PB94-964504  
EPA/ROD/R09-94/108  
July 1994

# **EPA Superfund Record of Decision:**

**Brown and Bryant Arvin Facility  
Site, Arvin, CA**

**RECORD OF DECISION**

Figure 3 : Brown & Bryant Media of Concern

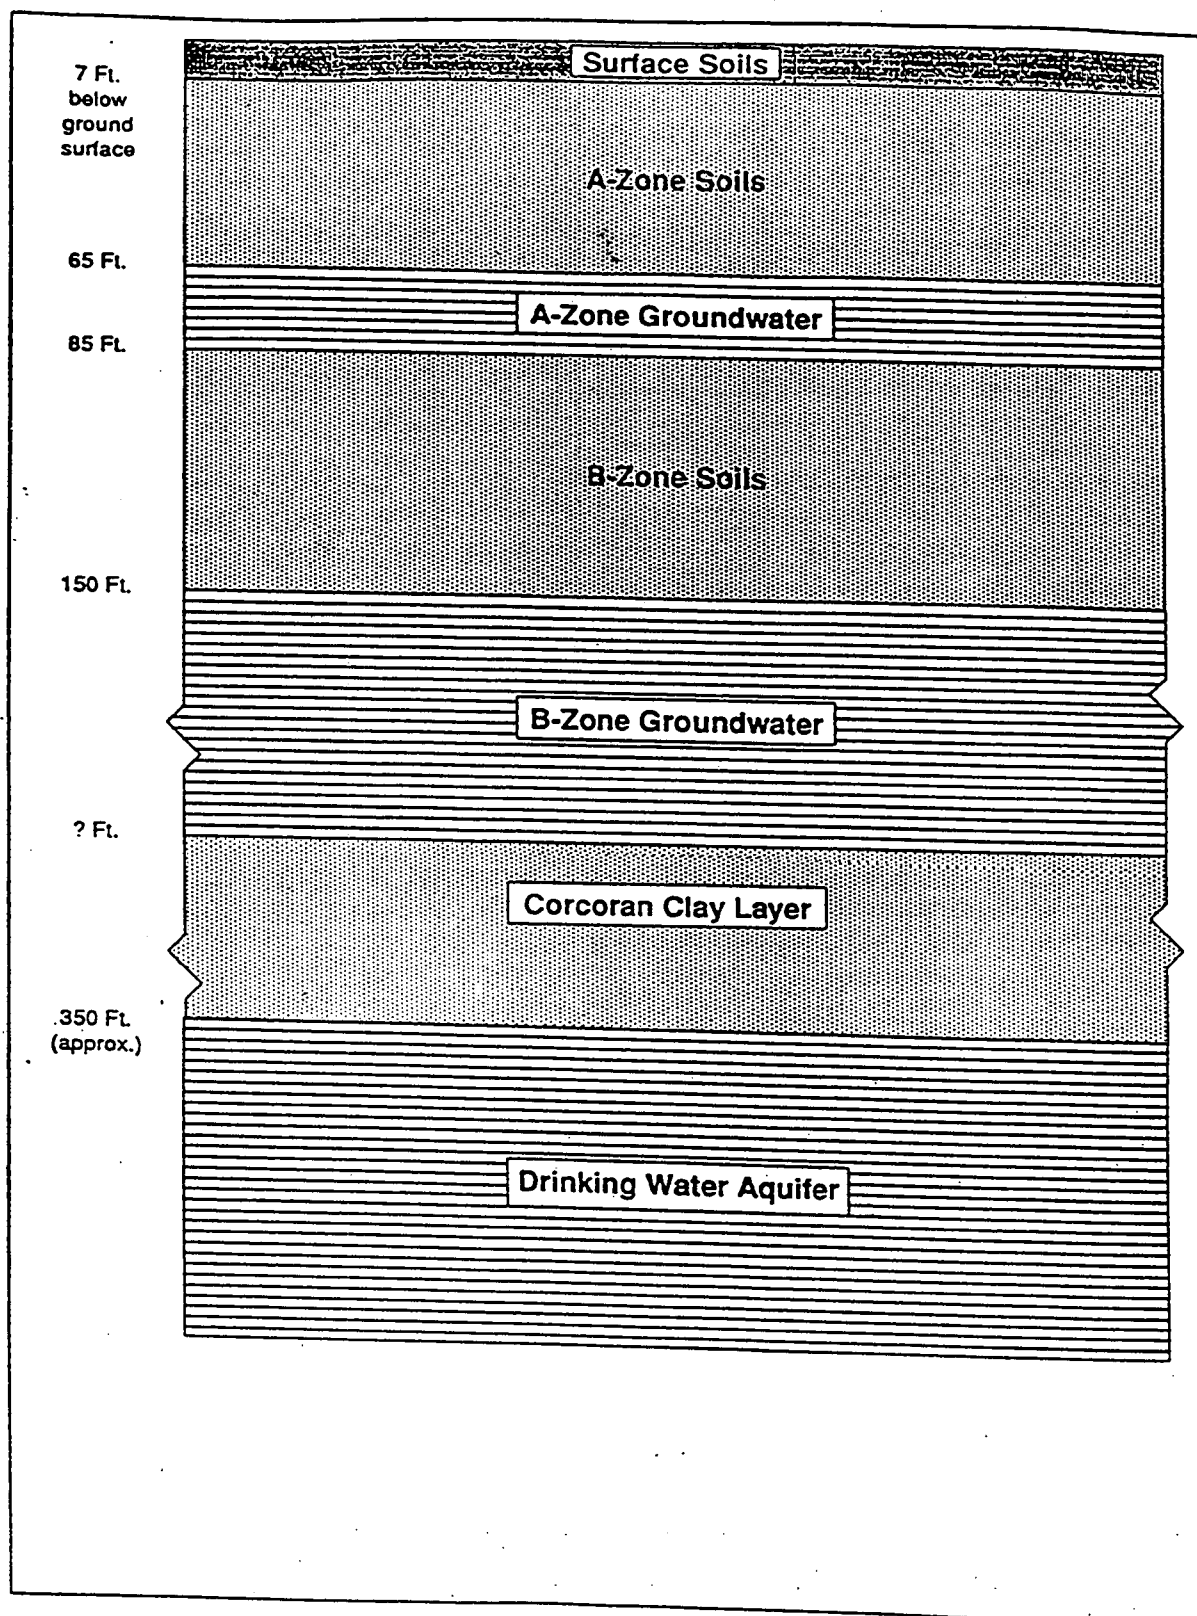
80. Figure 1.1 The figure does not depict any low-permeability layer underlying the A-zone water-bearing unit.

Response: This figure is a simplified cross-section intended to identify the general media of concern. A more detailed cross-section is included in Figures 3-3 and 3-4.
